Staff Report

Re: PLNSUB2018-00555 and PLNSUB2018-00665
TAG 700 Planned Development and Preliminary Subdivision

Planned Development and Preliminary Subdivision

PROPERTY ADDRESS: 2593 S. 700 East
PARCEL ID: 16-20-352-007
MASTER PLAN: Sugar House Master Plan
ZONING DISTRICT: RMF-30 (Low Density Multi-Family Residential)

Updated Front Façade

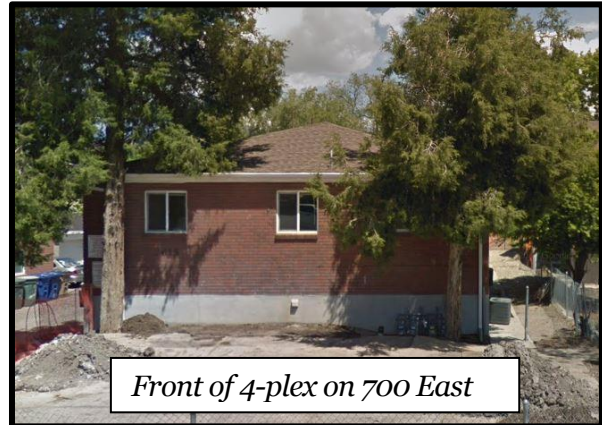
In response to staff and community council concerns regarding this lack of a front, the applicant revised their plans to emphasize the entryway by relocating the front door towards the center of the façade between two vertical window panes. The door will also be painted a light blue for additional emphasis against its white backdrop. The balcony was modified to wrap further around this façade, creating somewhat of a canopy above the front door and providing an element of human scale. Further, the entryway stands out on the front plane of the building while the side plane/patio area is slightly recessed. This patio area also increases the street presence off of the front

unit. Finally, additional windows and wood siding were added on the building's front to create a sense of balance and increased visual interest.

SITE PLAN 1
SCALE: 1:80 A001

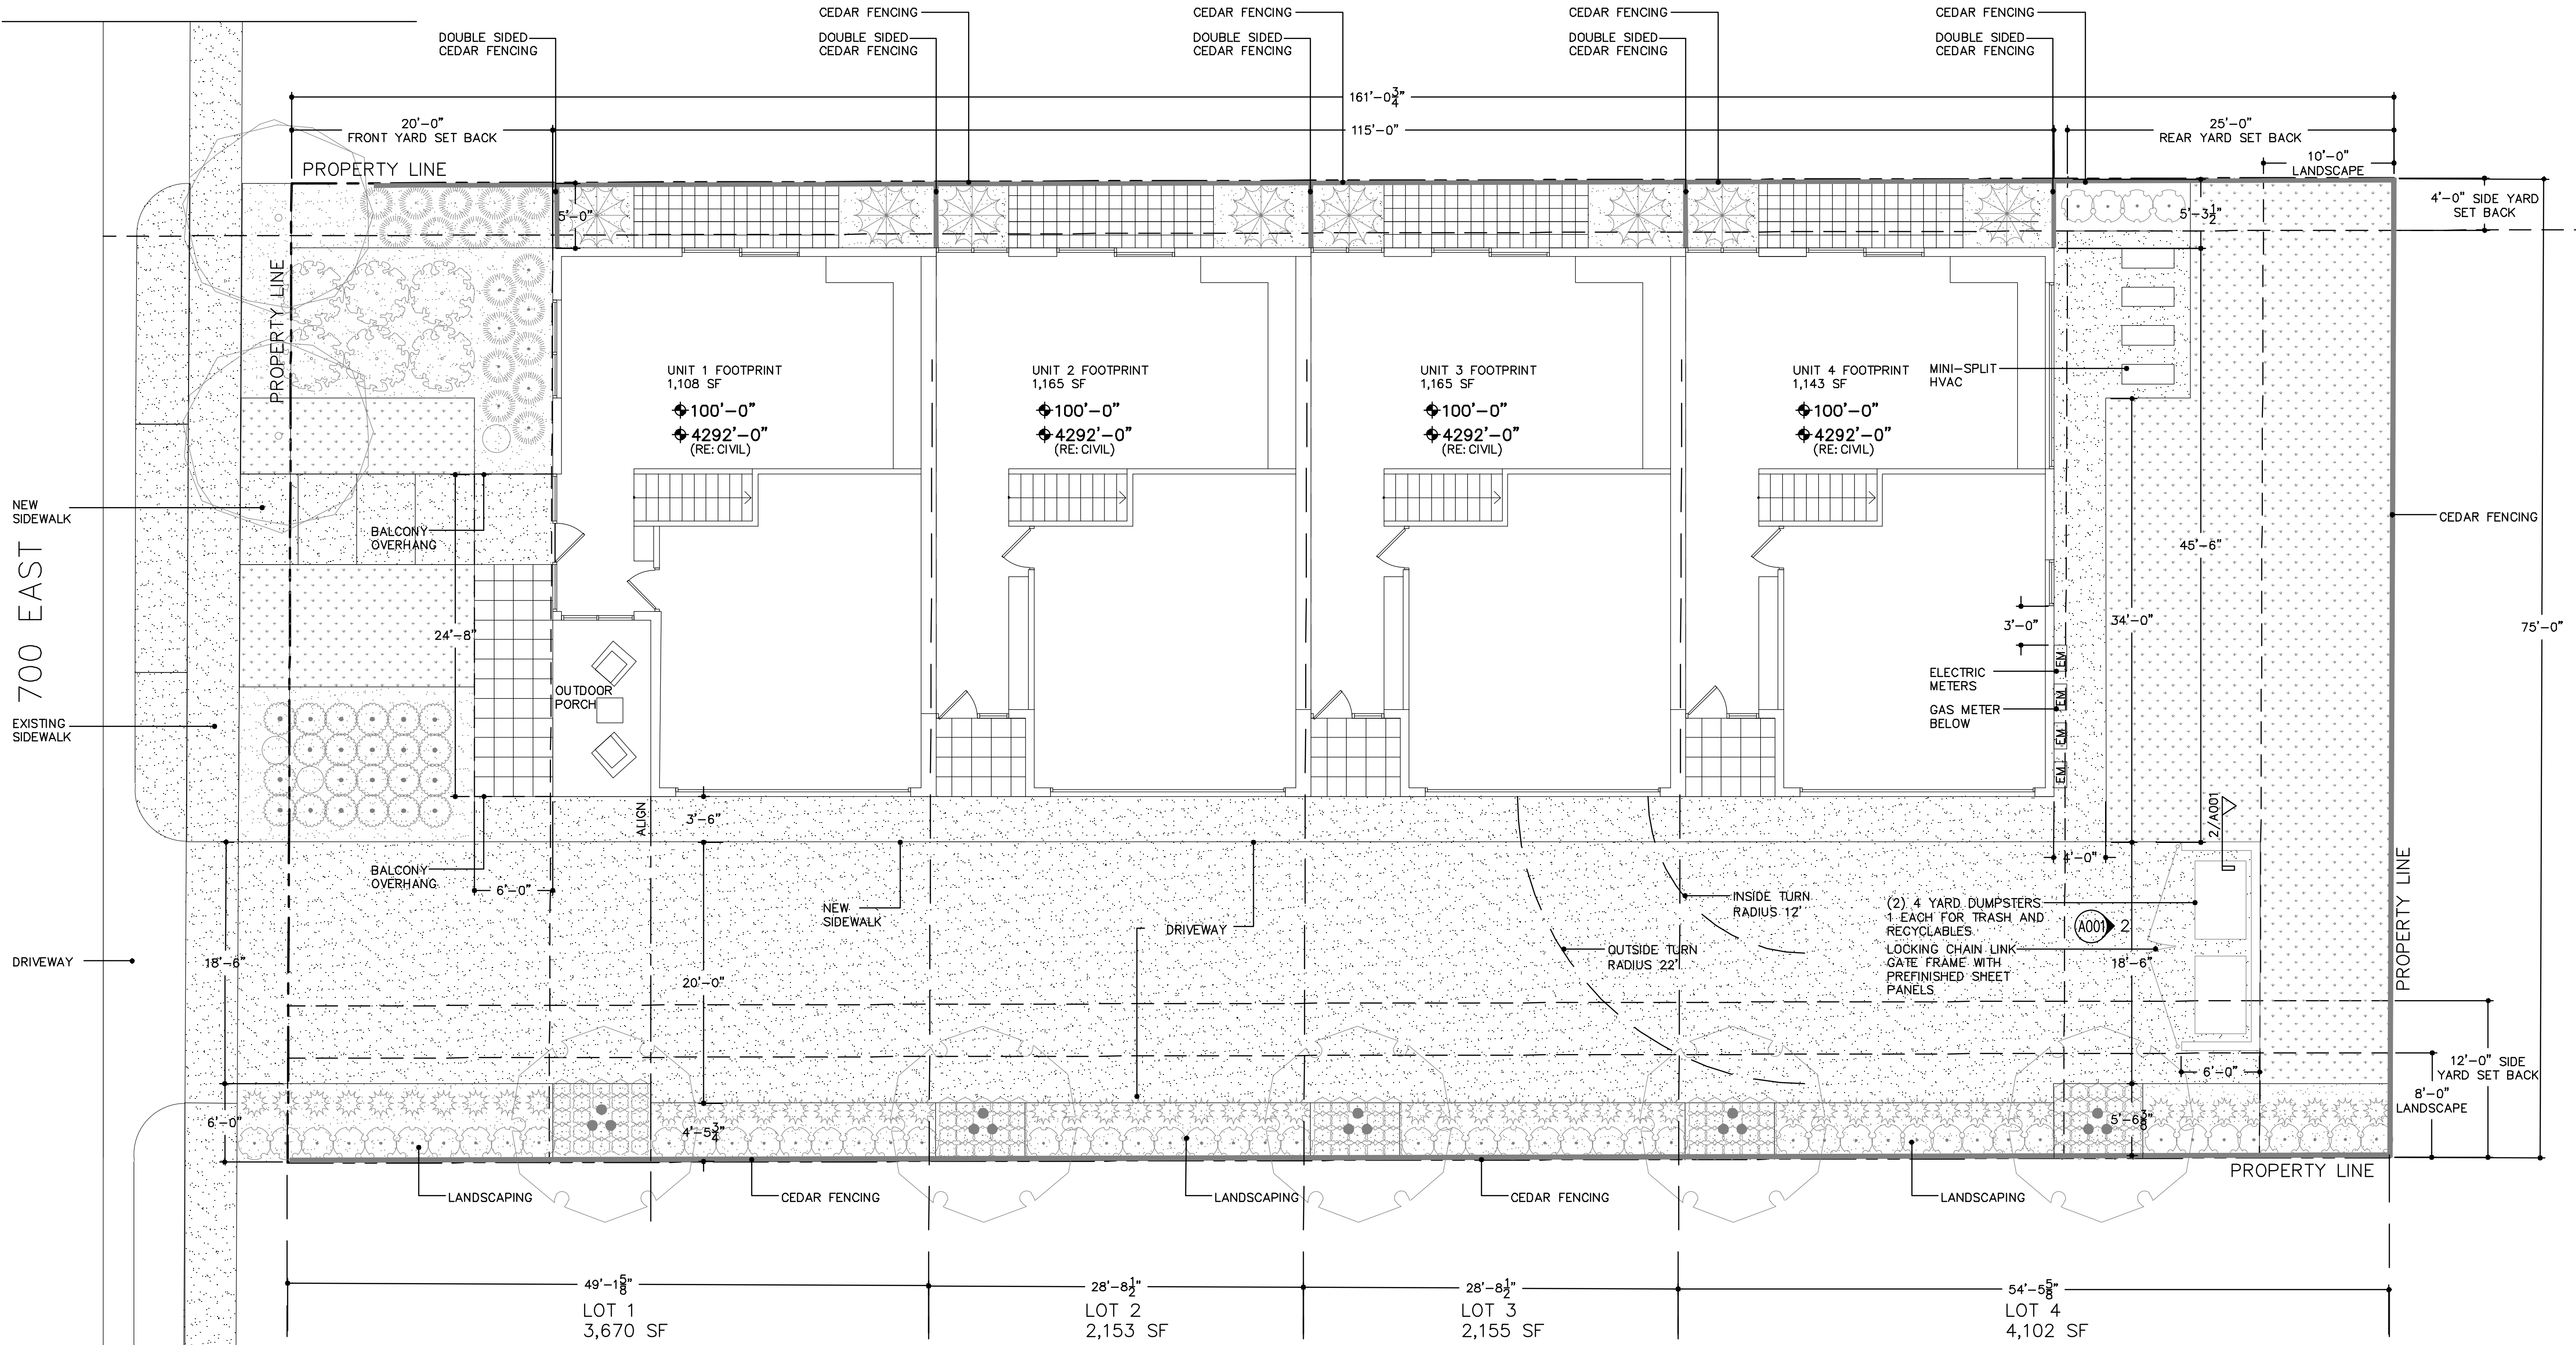
- 1.1.1. We are seeking an exception to this requirement via the Plan Development process.
- 1.2. Ground mounted A/C condensers must be 4 feet from any property line or require special exception approval from Planning per table 21A.36.020B

- 1.2.1. Please refer to the attached Site Plan. The HVAC units are located 5'-3 1/2" off the property line.
- 1.3. A completed Impact Fee Assessment worksheet will be required. A credit can be given for the one SFD being demolished. A demolition permit will be required.

- 1.4.1. The permanent recycle and trash enclosure are located on the Site Plan.
 - 1.4.2. A waste management plan will be issued prior to construction.
